LIDO 14 CLASS ASSOCIATION

APPROVED CHANGES and DISALLOWED CHANGES

Revised per 2016 Annual Meeting July 2016

Lido 14 Mast Preventer

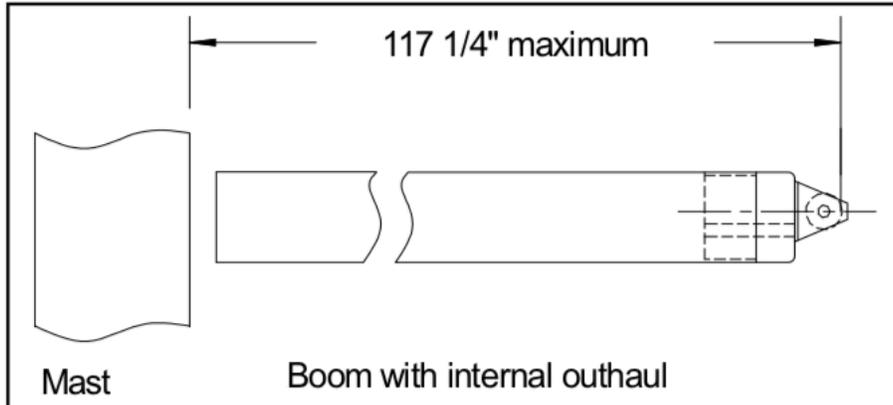
44. A mast preventer may be rigged between mast and shrouds.

Approved Change # 44

1. S/S strap (e.g. RF27) attached to mast with pop rivet or sheet metal screw
2. 1/16" covered 7x7 wire. 2 pieces
3. 1/16" nico press. 4 pieces.
4. 3/32" S/S thimble. 4 pieces

Measurement of boom maximum length with sheave at aft end for internal outhaul per Approved Change 73

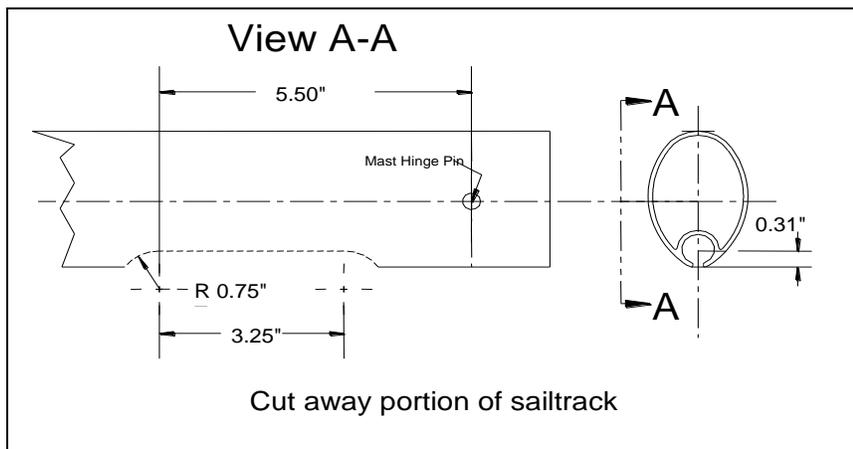
72. May 2001: The "Classic Lido" mast butt fitting is allowed for use on all Lido 14s.
73. July 2001: A roller fitting (Ronstan RF 453 or equivalent) may replace the stock cast boom end fitting and be attached to the end of the boom to guide a single outhaul line from the clew of the mainsail either around or to the inside of the boom. Blocks and line may be attached to the outhaul in any combination to gain mechanical advantage. The angle of the line from the clew to the end of the boom must be essentially the same as with the stock factory fitting, and all rigging must be within or attached to the boom.
